4 December 2007

RE: Response to the request for additional information regarding the SS&D evaluation for the
KRT-2000 Betavoltaic Power Cell

**Additional Information for the Application Requesting Sealed Source and Device Registry
of the KRT-2000 Betavoltaic Power Cell (QynCell™)**

Feedthrough

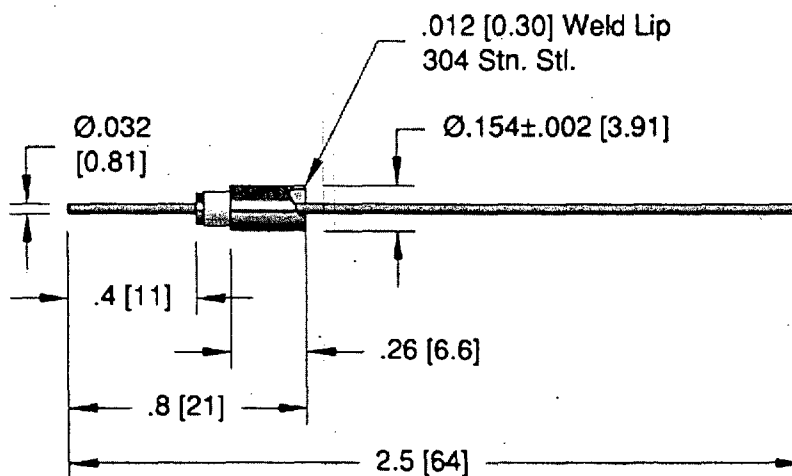
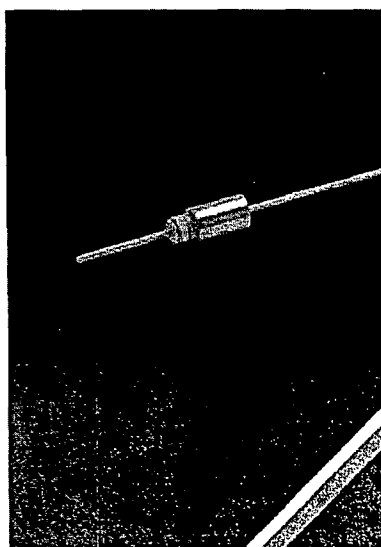
- 2.2. In response to your inquiry regarding the electrical feedthrough, we have attached the specification sheets and drawings from CeramTec for this part. It is a Ceramaseal 9297-06-W. The material list includes 304 stainless steel for welding, alumina ceramic for electrical isolation, and Molybdenum for electrical connection. We have also attached excerpts from testing of an early design of the KRT-2000 performed at NAVSEA Crane. This testing was preliminary testing of prototypes for the express purpose of finding any potential areas of improvement in the design that would make the KRT-2000 more robust and reliable. The feedthroughs used in the final design of the KRT-2000 were also used in the early prototype with identical welds. These devices were subjected to 100 Mrad of radiation from a ^{60}Co gamma source and then helium leak checked. This dose far exceeds the dose expected under normal operating conditions. Calculations have determined that in a normal use environment for the KRT-2000, the components of the device would be exposed to a total of 0.25 Mrads of dose over its twenty year lifetime from a 5 Ci loading. Also, the dose is primarily from ^{85}Kr gammas which have a peak energy of 514 keV. These do far less damage than the high energy gammas from ^{60}Co (peak energy 1332 and 1173 keV). In all cases no leak was detected after the radiation hardness environmental test.
